SAFETY RECALL

SR16-86B

REVISION B: THIS REVISION SUPERSEDES PREVIOUS VERSION

12-VOLT POWER SOURCE RELAY REPLACEMENT 9700 (B13R)

FIGURE 1: WIRING DIAGRAM SHOWING K918 & K919 – EQUIPPED WITH ALLISON TRANSMISSION

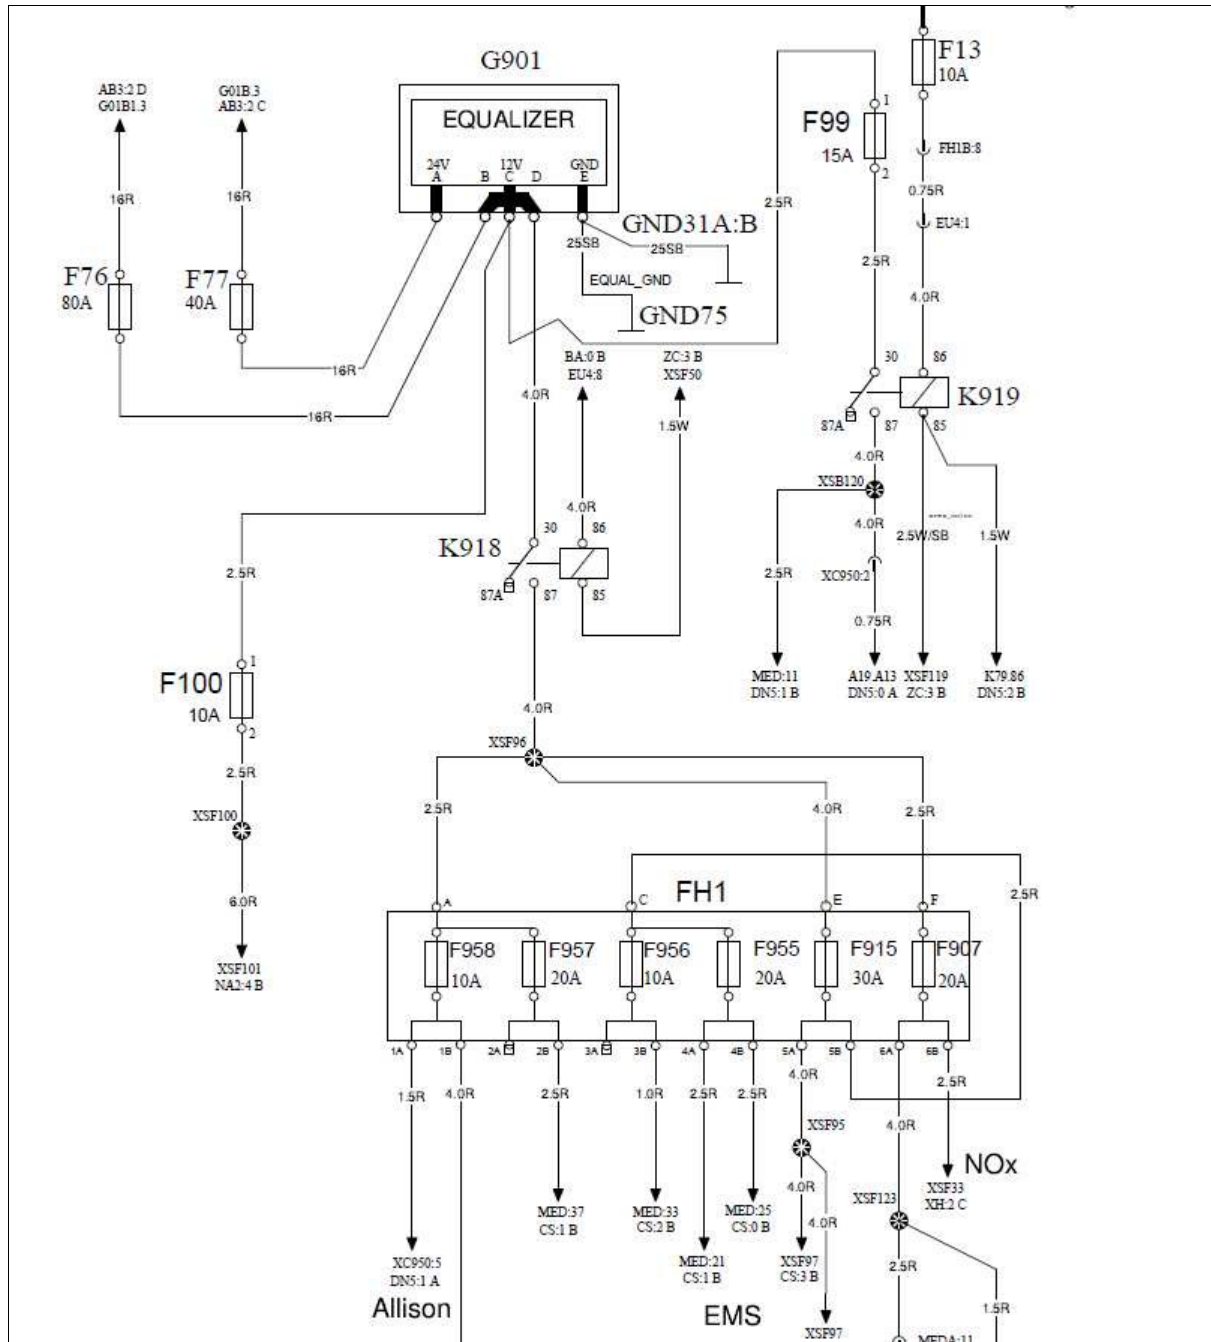
The 12-volts power source relay(s) currently installed on the vehicle may fail, resulting in an engine shut down while driving. A new type of relay equipped with a coil that can hold a higher current must be installed to improve the vehicle reliability.

FOUR SCENARIOS PRESENTING FOUR SOLUTIONS DEPENDING ON THE MANUFACTURING DATE (V.I.N.) AND TRANSMISSION MODEL

RANGE	WHAT TO DO
Model Year: up to 2013 Vehicles up to 3CET2S22XD5 <u>160297</u>	Relay K917: Replace existing relay K917 with relay p/n 21244697 (Cartier Mini) Relay K918: Replace existing relay K918 with relay p/n 564218 (Cartier Maxi). Refer to the following instruction.
Model Year: 2013 – 2015 From 3CET2S225D5 <u>160756</u> up to 3CET2V227F5 <u>168569</u>	Relay K918: Replace existing relay K918 with relay p/n 564218 (Cartier Maxi). Refer to the following instruction.
Model Year: from 2015 Equipped with Allison transmission From 3CET2V224F5 <u>169811</u>	Relay K919: Replace existing relay K919 with relay p/n 21244697 (Cartier Mini) Relay K918: Replace existing relay K918 with relay p/n 564218 (Cartier Maxi). Refer to the following instruction.
Model Year: from 2015 Equipped with I-Shift transmission From 3CET2V224F5 <u>169811</u>	Relay K918: Replace existing relay K918 with relay p/n 564218 (Cartier Maxi). Refer to the following instruction.
